ENGINEERING REPORT ER493.04

BARREL NUT RETAINER BELL 206B, 206L, 407

Revision 0 Date: 01 May 2012

DRAWING CHANGE NOTICE

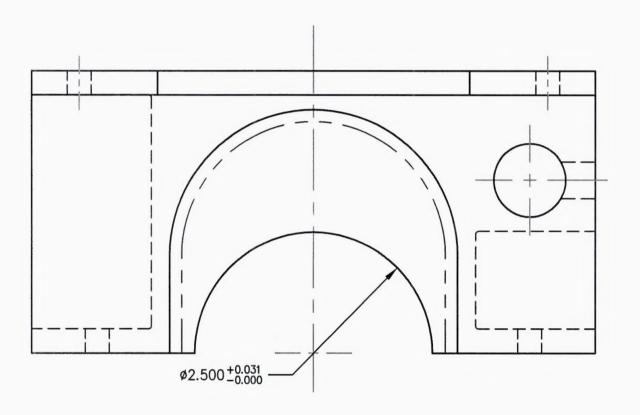
We have been getting feedback from customers, and it will make the saddle fit better on the landing gear crosstubes if we change the diameter of the saddle curve.

SADDLE DIMENSION WAS 2.437" SADDLE DIMENSION IS 2.500"

01) FORWARD FITTING

Figure 1.1 Changed Geometry of Forward Fitting Flanges (Aft Ftg Similar)

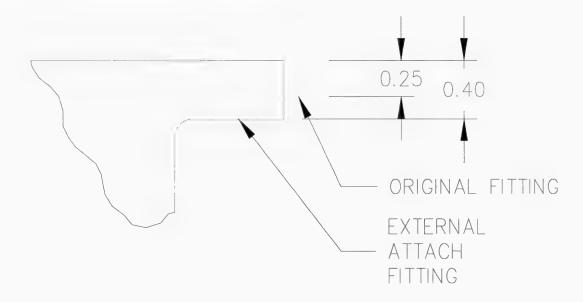
Drawings 49311 and 49312 have been revised in order to reduce the thickness of the upper flange to that of the original Bell parts.

Figure 1.1 Changed Geometry of Forward Fitting Flanges (Aft Ftg Similar)

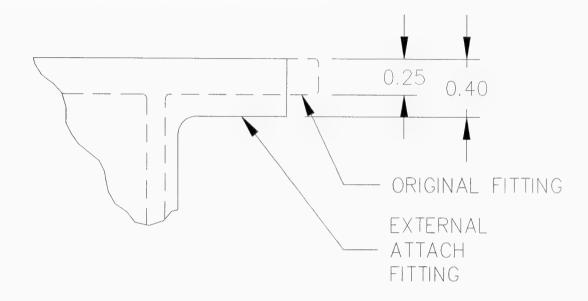
Drawings 49311 and 49312 have been revised in order to reduce the thickness of the upper flange to that of the original Bell parts.
